PLANS AND DOCUMENTS
referred to in the **APPROVAL**
Dated: **23/06/2026**

**Drawing Title:
Development Footprint Plan
Document No. SK01**

**BCC DS
RECEIVED
26/05/2026
APPLICATION REF
A006865970**

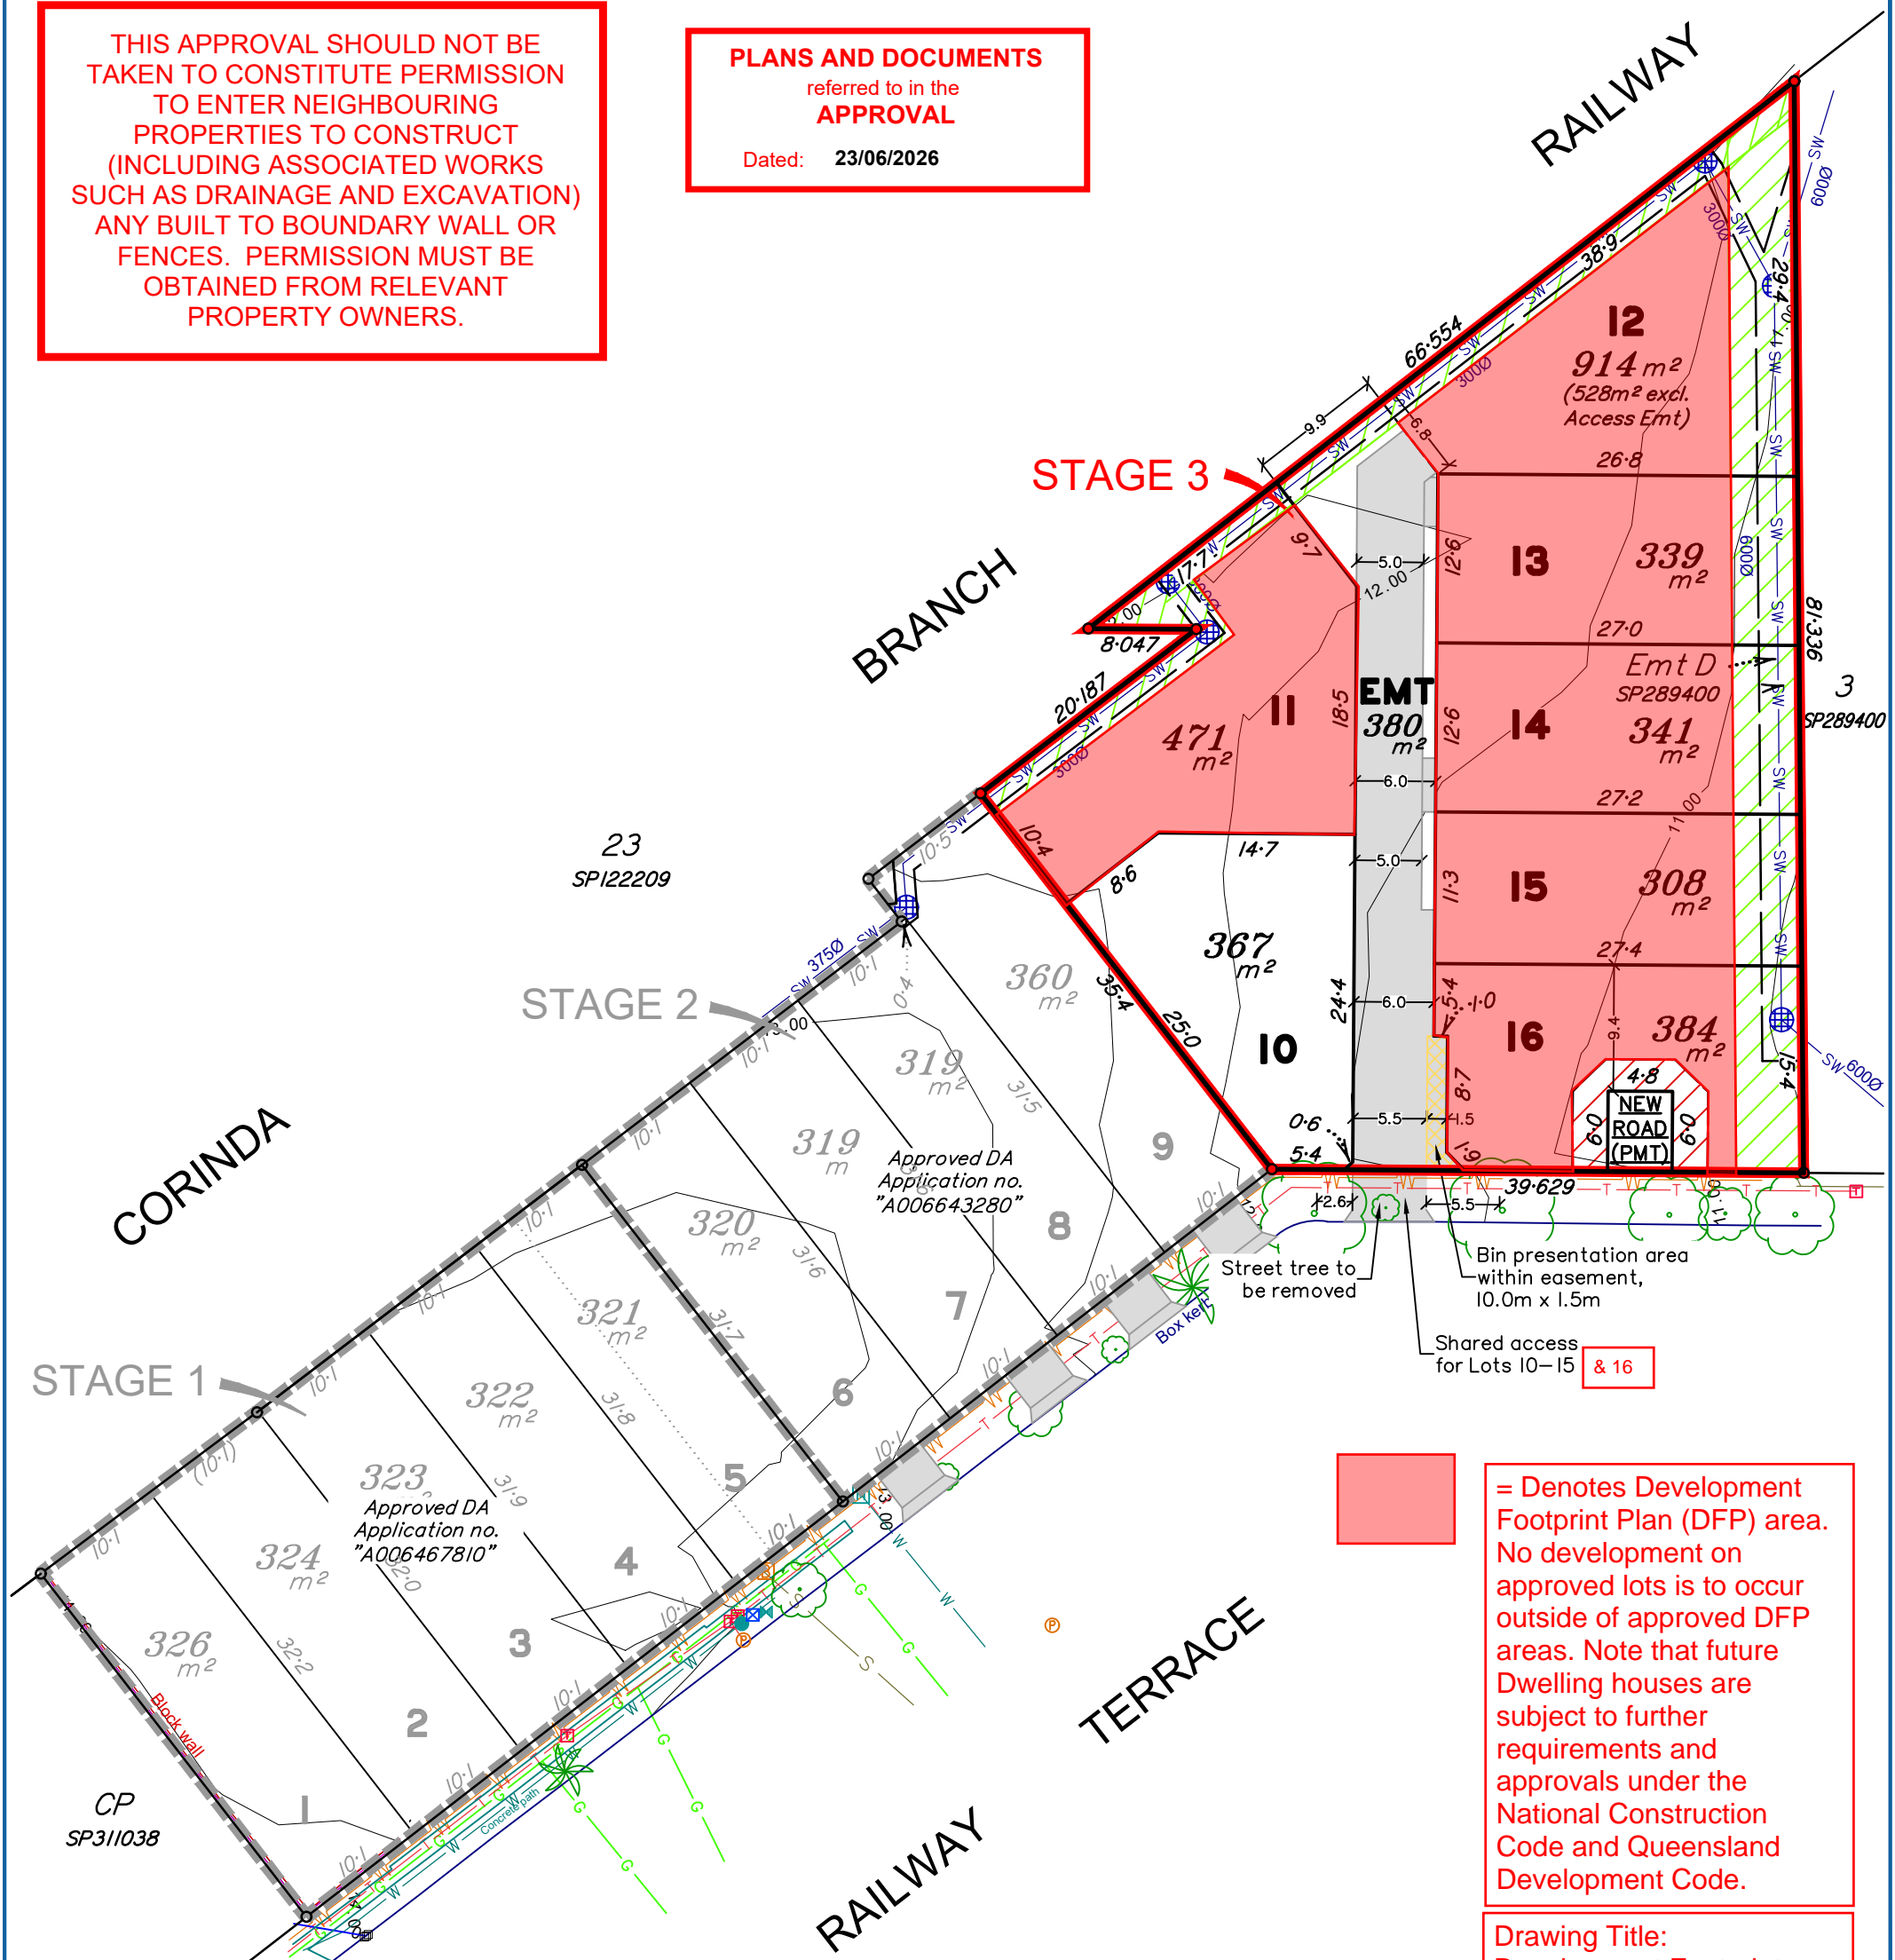
The landscape buffers are to include organic mulch to a minimum depth of 100mm and a physical garden edge along the perimeter of the buffer internal to the lot.

Planting densities for the bus depot boundary buffer are to achieve the following:
 Trees - 1 per 6sqm
 Shrubs - 1 per 2sqm
 Groundcovers - 3 per 1sqm

Consider utilising an increased variety of groundcovers.

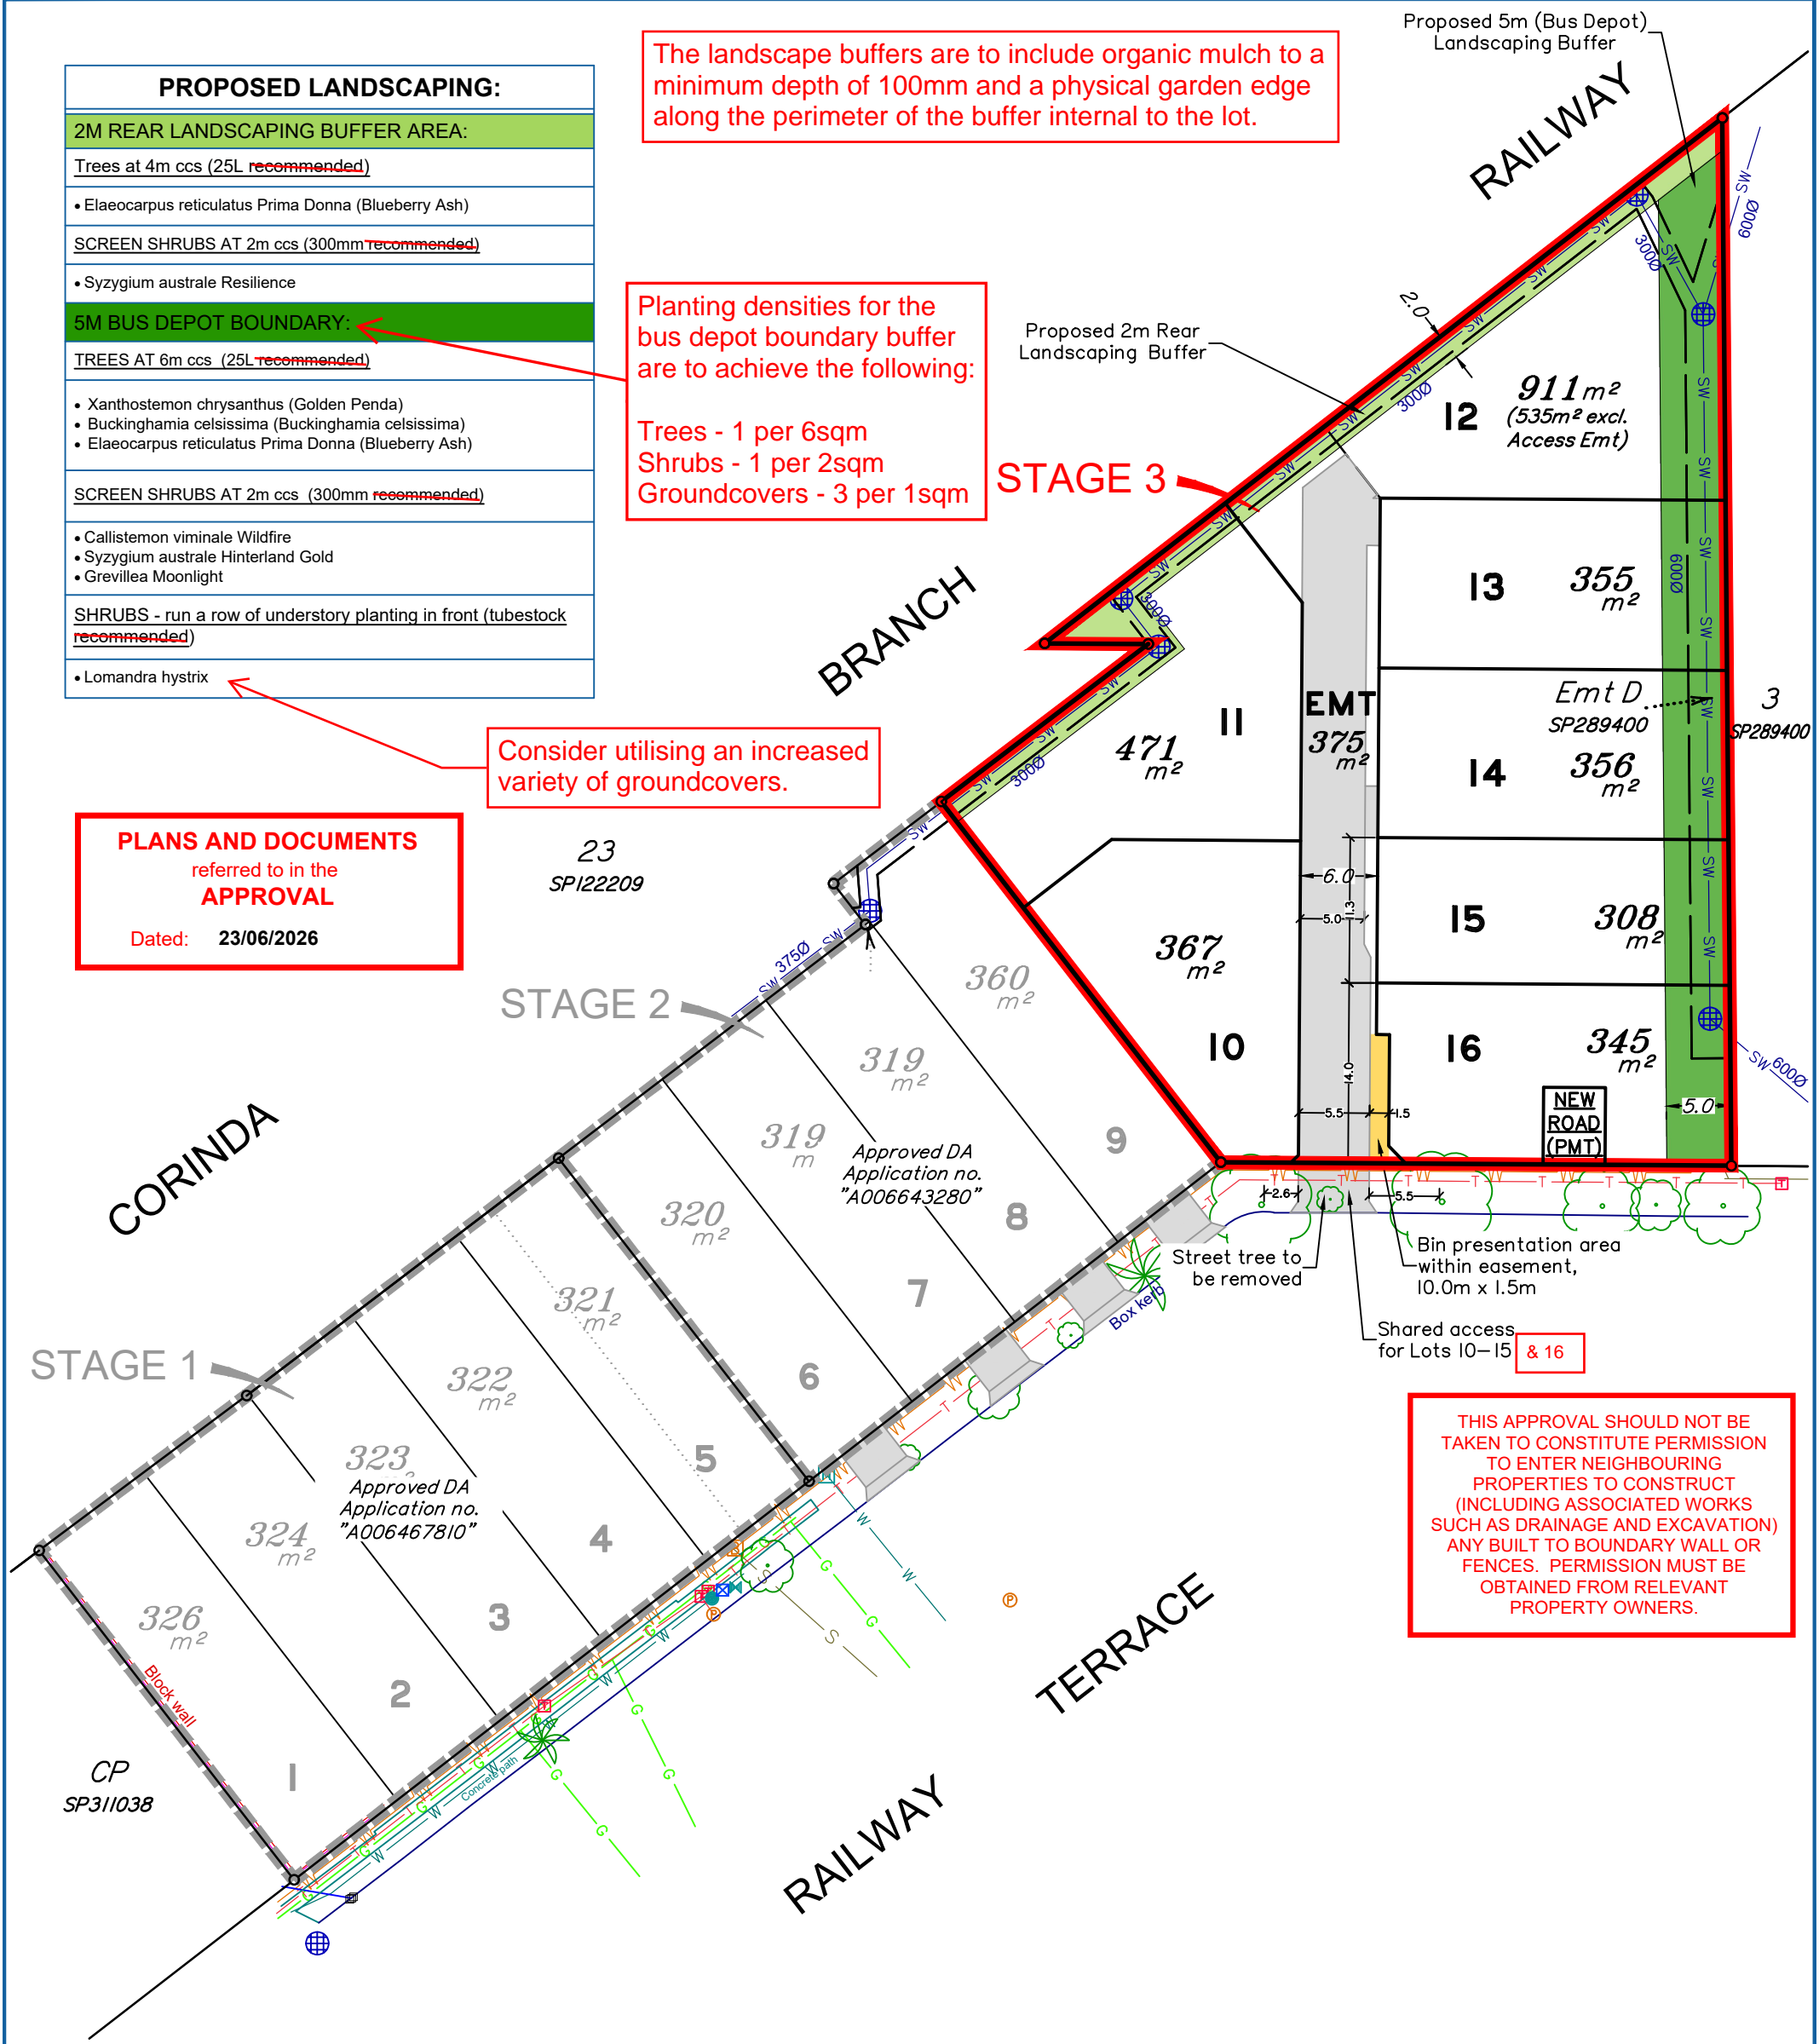
AMENDED IN RED
 30/04/2026
